North Eastern Regional Power Committee

Sub: 78वीं संरक्षण समन्वय उप-समिति (पीसीसी) बैठक का कार्यवृत्त/ Minutes of 78th Protection Coordination Sub-Committee (PCC) Meeting

78th Protection Coordination Sub-Committee Meeting

Date: 21/04/2025 (Monday)

B.8 Grid Disturbance in Tuirial S/S of NEEPCO & Kolasib and Bairabi areas of Mizoram Power System on 20-03-2025:

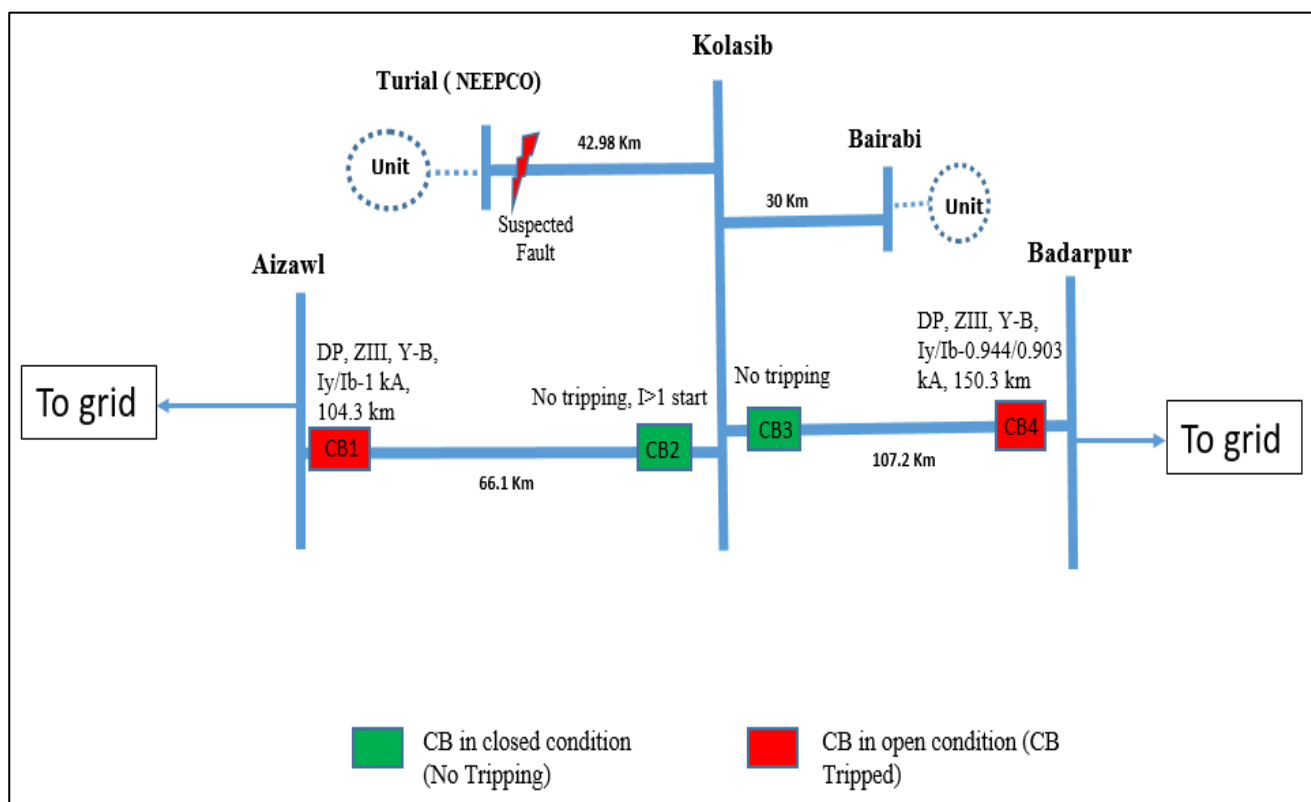
- Fault is suspected in 132 kV Kolasib-Tuirial line which was not cleared from Kolasib end resulting in tripping of healthy 132 kV Aizawl-Kolasib and 132 kV Badarpur-Kolasib lines from remote end on operation of DP, ZIII.

- Protection system of 132 kV Kolasib-Turial line failed to isolate the fault. P&ED Mizoram needs to ensure healthiness of protection system of 132 kV Kolasib-Turial line.
- Non-submission of Flash report and detailed report by P&ED Mizoram & NEEPCO which is a violation of Clause 37.2 (b) & 37.2 (e) of IEGC regulation 2023.

NEEPCO updated that Turial was under shutdown at the time, therefore no-fault current was observed at Turial end.

Mizoram informed that fault was cleared from Kolasib end although no relay pick up was observed. Further he stated that Distance relay at Bairabi end for the Kolasib line has been replaced as there was some issue with it.

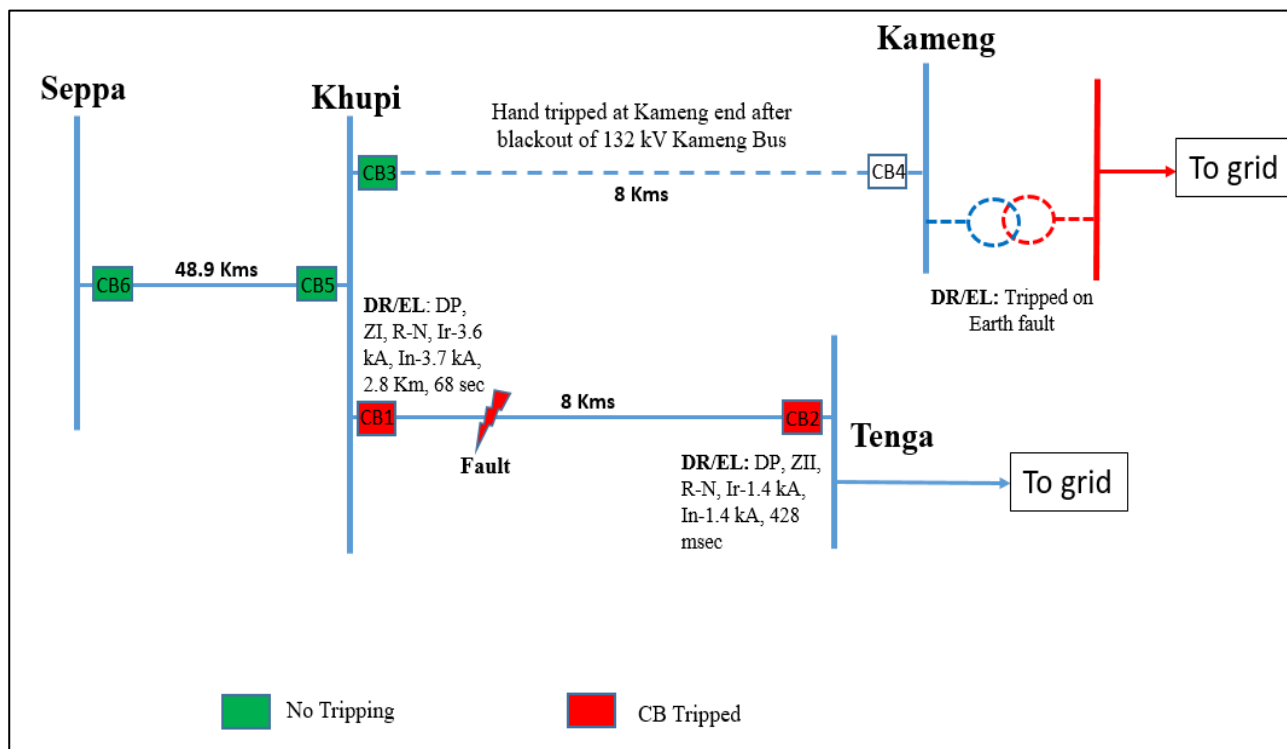
As per DR analysis, R-N fault (Ir-3.6 kA, In-3.7 kA) in 132 kV Tenga-Khupi line at a distance of 2.8 Km from Khupi initiated at 18:18:13.361 Hrs and cleared within 68 msec from Khupi end on operation of DP, ZI. Fault cleared within 428 msec from Tenga end on ZII.

At 18:18:14.141 Hrs, Kameng ICT tripped on E/F which seems to be unwanted.

B.10 Grid Disturbance in Mawlyndep area of Meghalaya Power system on 23-03-2025

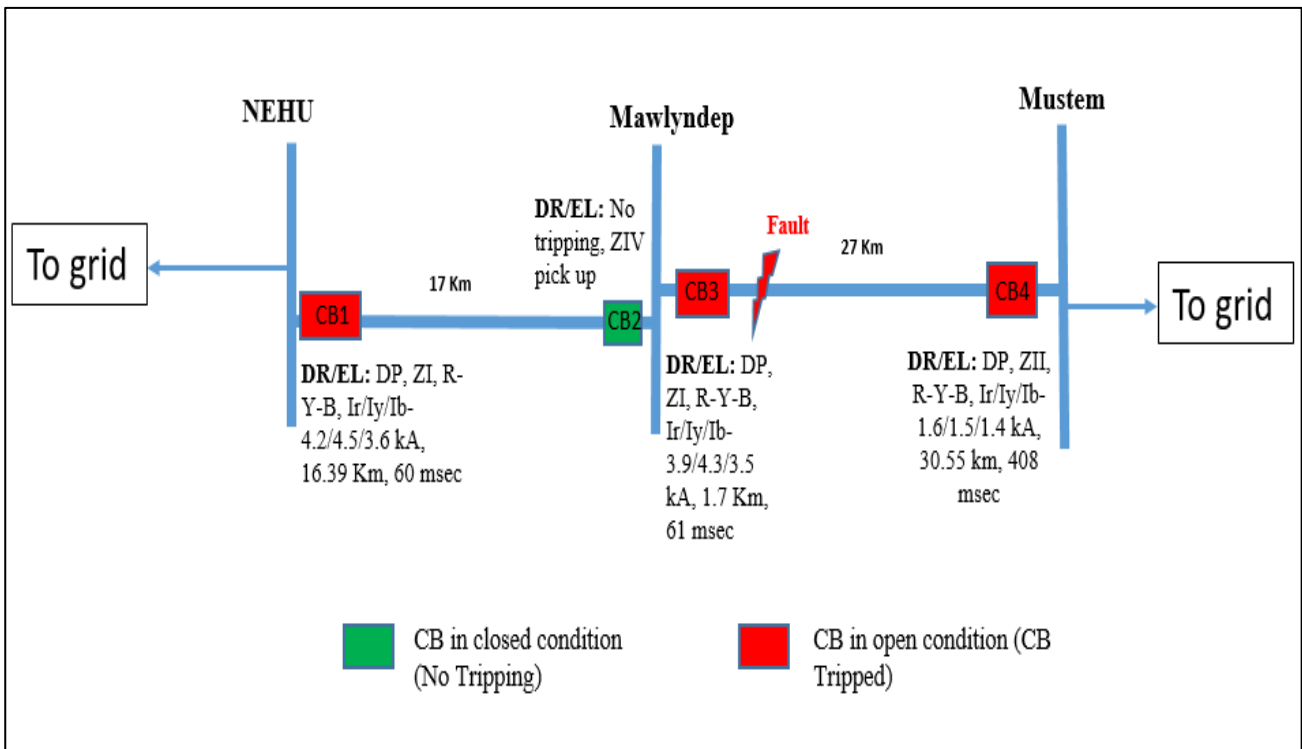
As per DR analysis, R-Y-B fault in 132 kV Mustem-Mawlyndep line with Ir-1.6 kA, Iy-1.5 kA, Ib-1.4 kA initiated at 12:06:38.585 Hrs and cleared within 408 msec on operation of DP, ZII (fault distance- 30.55 Km) from Mustem end. Fault cleared within 61 msec from Mawlyndep on ZI. Carrier was send from Mawlyndep end. However, Mustem CB tripped after ZII time delay.

B.11 Grid Disturbance in Loktak HEP of NHPC & Rengpang area of Manipur Power system on 24-03-2025

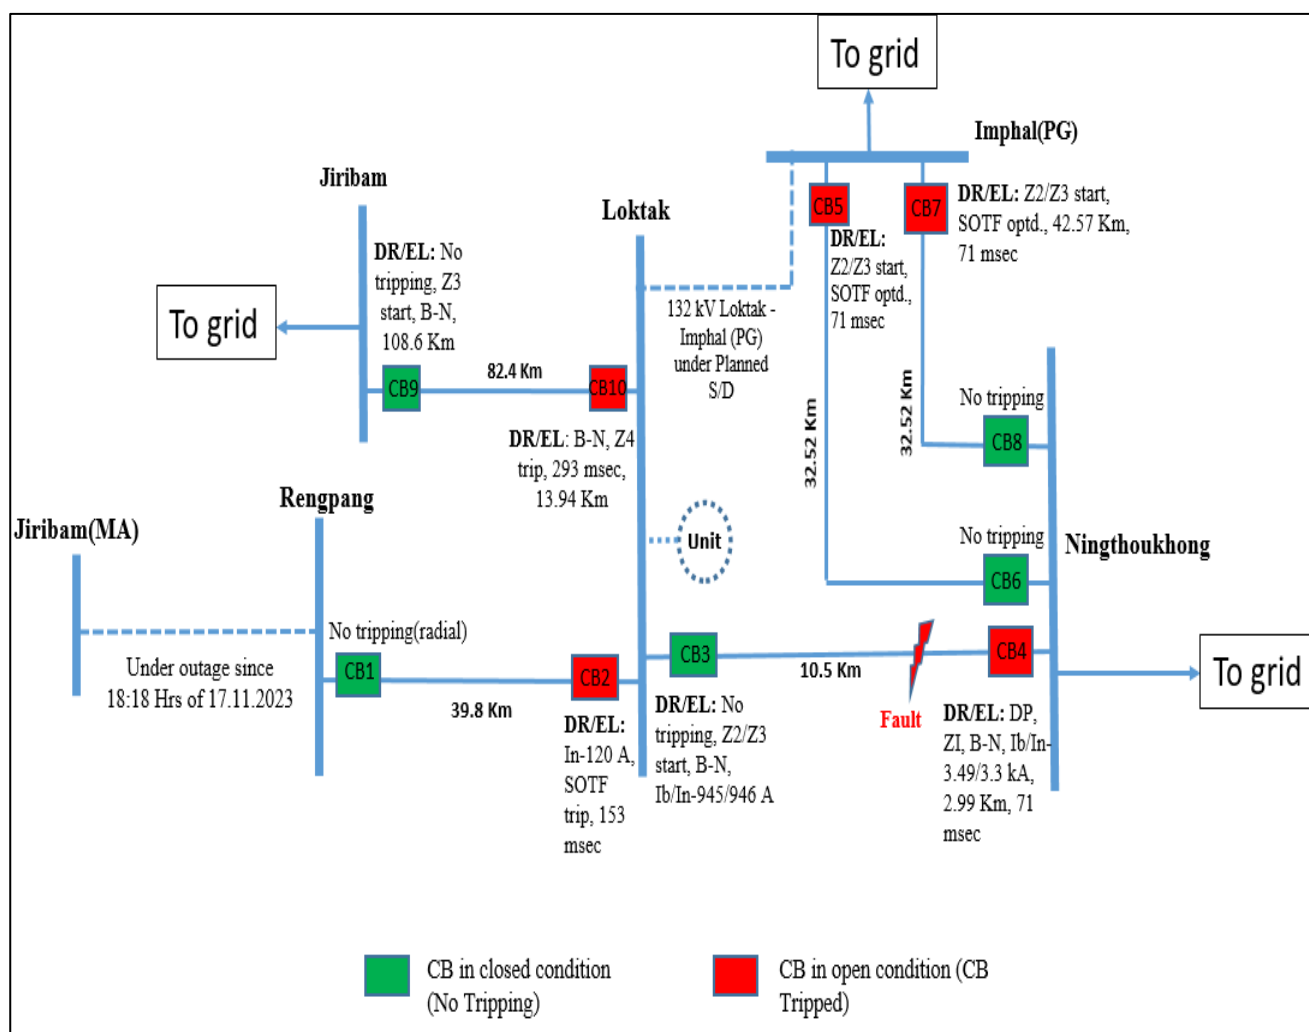
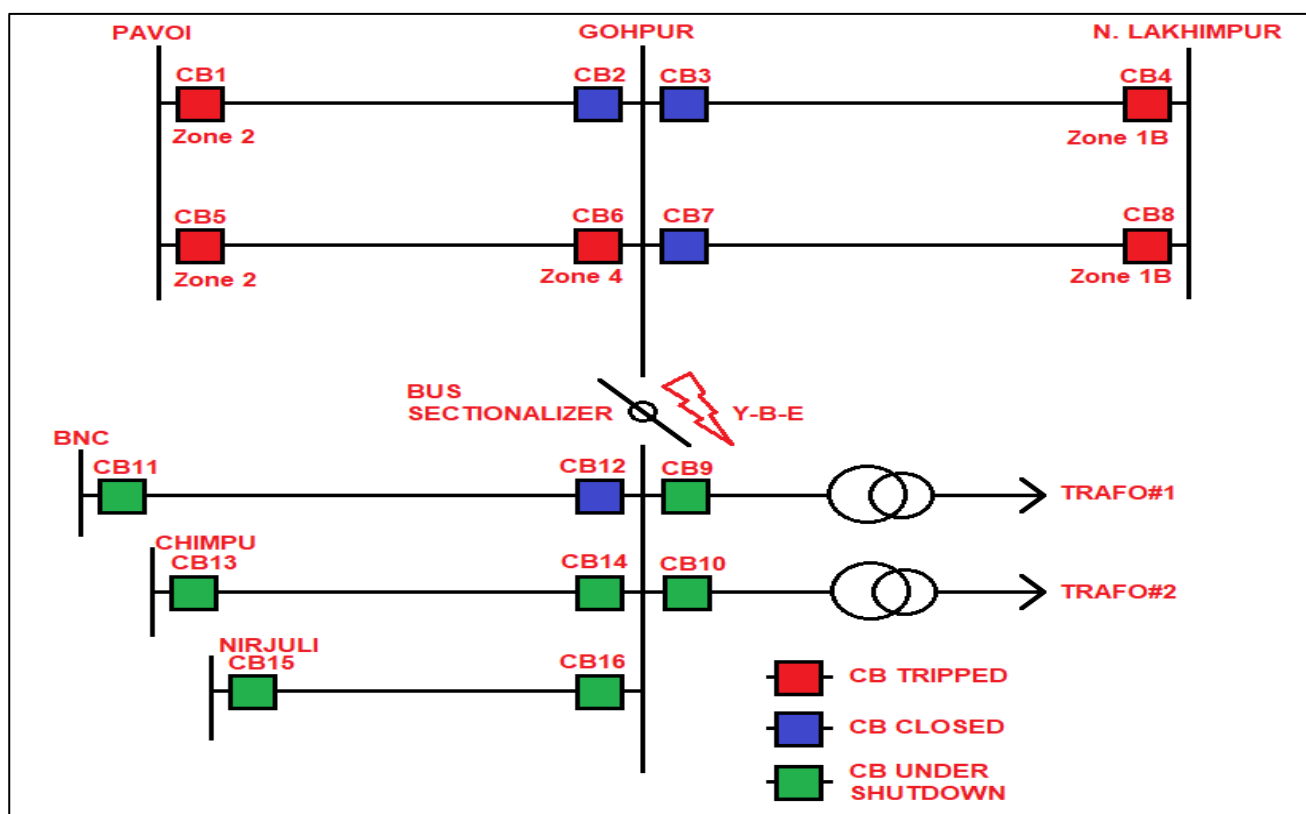
As per DR analysis, resistive B-N fault (Ib-3.49 kA, In-3.3 kA) in 132 kV Loktak-Ningthoukhong line at a distance of 2.99 Km initiated at 11:38:07.129 Hrs which was cleared within 71 msec from Ningthoukhong end on operation of DP, ZI. ZII started at Loktak end (no tripping) and fault current disappeared within 293 msec. 132 kV Loktak-Jiribam line tripped from Loktak end on Z4 within 293 msec (FD: 13.94 Km). Z3 start from Jiribam end and no tripping.

NHPC informed that there is no LBB protection at Loktak S/S and Z4 time delay was kept at 200-250 msec at Loktak for 132 kV Jiribam Line.

1. Implement PLCC and Line differential protection on the Loktak Ningthoukhong (10.5 Km) line
2. Review and rectify the Z4 timing and reach at Loktak end for the Jiribam line
3. Rectify the SOTF issue at Loktak end for Rengpang line.
4. Submit detailed report of the grid event at Loktak.

B.14 Grid disturbance in 132 kV Umiam S/S of Meghalaya Power system on 01-04-2025:

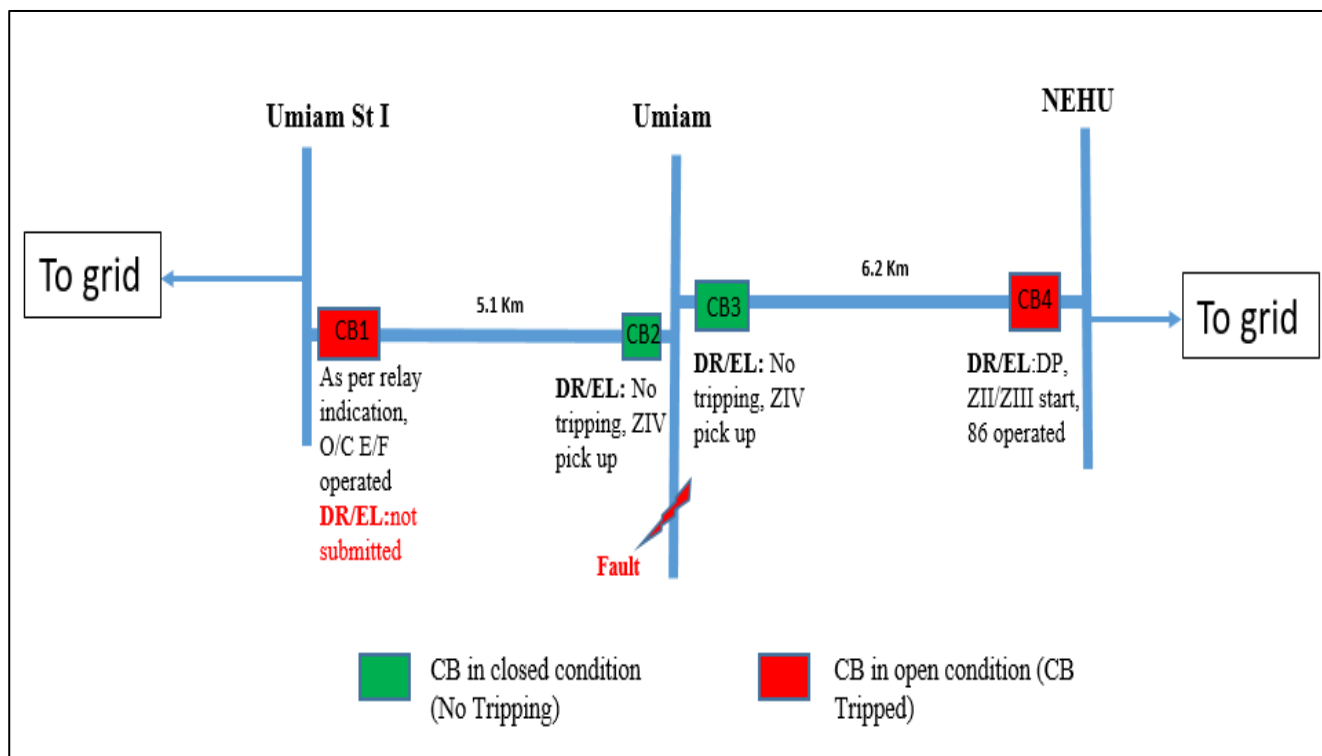
As per DR analysis, R-N fault (Ir-3.1 kA, In-2.9 kA) initiated at 01:55:31.117 Hrs which was cleared within 121 msec from NEHU end. ZII/ZIII start and 86 operated at 01:55:31.202 Hrs. Z4 pickup at Umiam end (no tripping).

MePTCL/MePGCL is requested to provide update on the above-mentioned issues

B.16 Tripping of 220/132 kV Kopili ICT-II on 17.03.2025

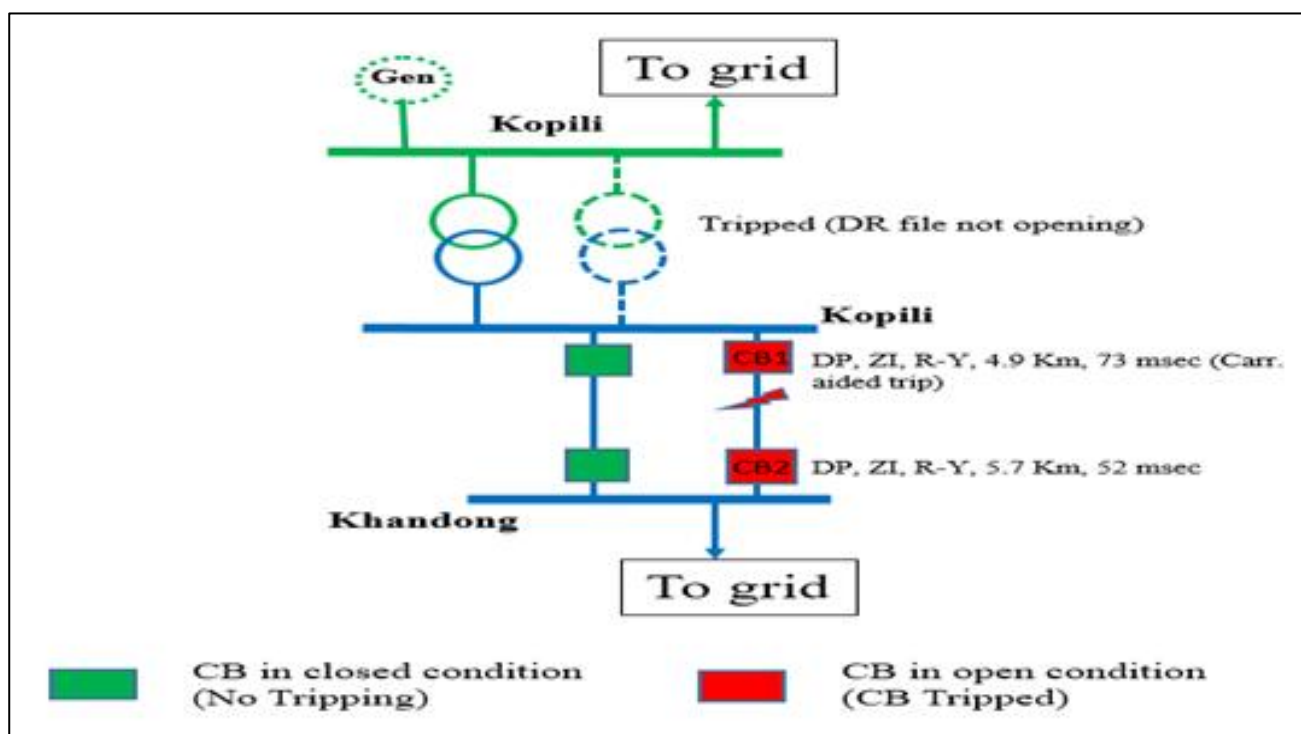
As per DR analysis, R-Y phase fault (Ir-3.2 kA, Iy-3.3 kA) in 132 kV Khandong-Kopili I line initiated at 13:53:51.371 Hrs and cleared within 52 msec on operation of DP, ZI from Khandong end. At Kopili end, fault cleared within 73 msec on operation of DP, ZI (Carrier aided tripping).

NEEPCO informed that the tripping of ICT occurred due to some issue with EFP logic and the same has been rectified now.

B.17 Multiple Tripping of 132 kV Pare-Itanagar & 132 kV Panyor-Itanagar Lines on 28-03-2025:

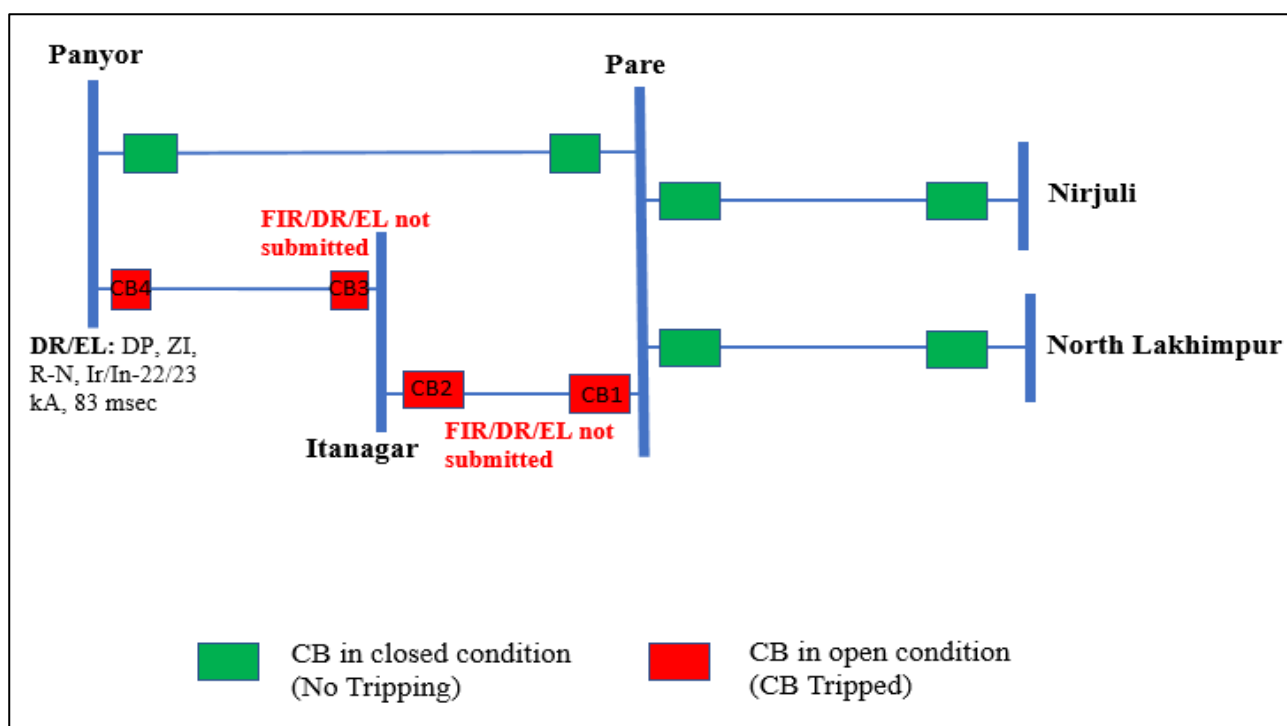
As per DR analysis, R-N fault (Ir-22 kA, In-23 kA) initiated at 18:10:13.739 Hrs which was cleared within 83 msec from Panyor end on operation of DP, ZI.

1. **TMS for I> (SI curve)** is set at **0.03**, against the recommended value of 0.1, providing minimal time discrimination margin for downstream fault clearance.
2. **Pickup current** is configured at **39 A (Primary)**, which is considerably lower than the recommended settings. This setting should be revised upwards to allow for better coordination.
3. **I>> (DT function)** is set at **150 A (Primary)** with **0 sec time delay**. The pickup is not only considerably lower than the recommended settings, but also lower than the recommended pick up for stage 1 protection, causing

In view of the above, it is requested that the protection settings at the POWERGRID end be reviewed and revised in line with the NER Protection Protocol to ensure proper coordination, selective tripping, and overall system reliability.

C.4 Grid Disturbance in Along area of Arunachal Pradesh on 15-02-2025:

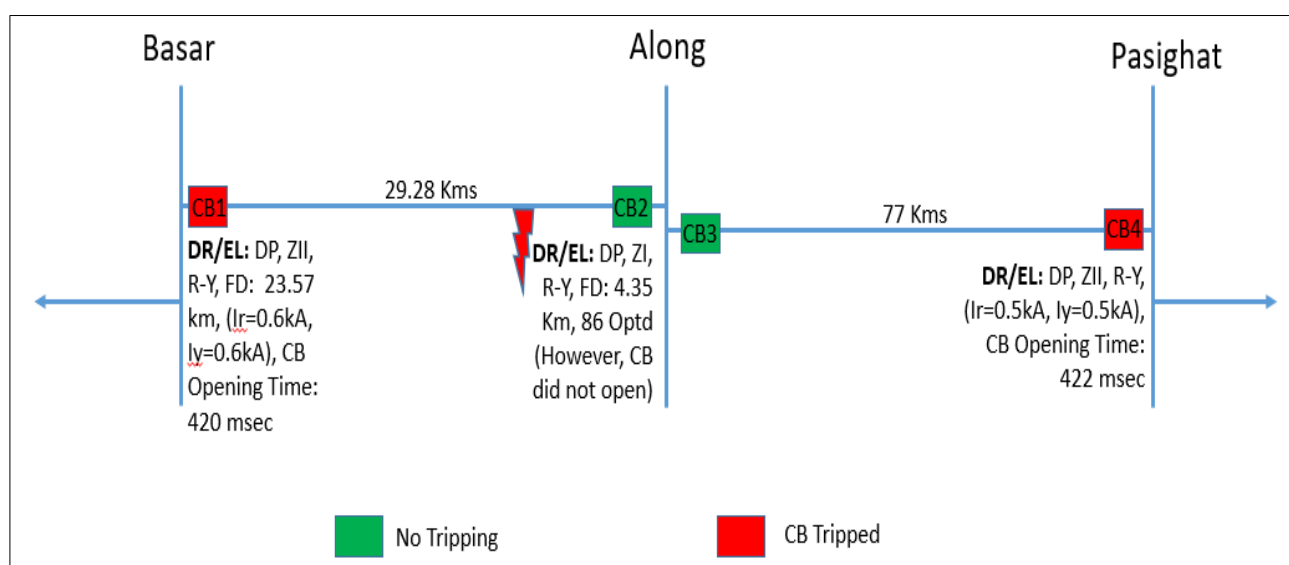
As per DR analysis, high resistive R-Y fault (Ir-697 A, Iy-683 A) in 132 kV Along-Basar line initiated at 00:39:00.712 Hrs which was cleared within 420 msec from Basar end on operation of DP, ZII, R-Y, FD: 23.57 km. ZI started from Along end and trip command issued. However, CB at Along fails to open. Non-isolation of fault from Along, resulted in clearing of fault from remote end by tripping of 132 kV Pasighat-Along on DP, ZII, R-Y, within 422 msec.

It is to be mentioned that similar kind of disturbance observed on 08th Dec'24, 23rd January'25 and 05th Feb'25 and it was already highlighted in the 75th & 76th PCC meeting. In the 76th PCCM, DoP Arunachal Pradesh updated that CBs at Along to be replaced and proposal have been put up to higher authorities. DoP AP informed that they are facing fund issue for procurement of CB. Also, there are no spare CB available. The forum strongly advised DoP Arunachal Pradesh to replace the CBs on urgent basis as multiple blackouts have occurred due to the CB issue.

DoP Arunachal may provide an update on the actions taken in response to the aforementioned observations.

Zone III settings at Pasighat modified from 120% to 100% as informed by POWERGRID.
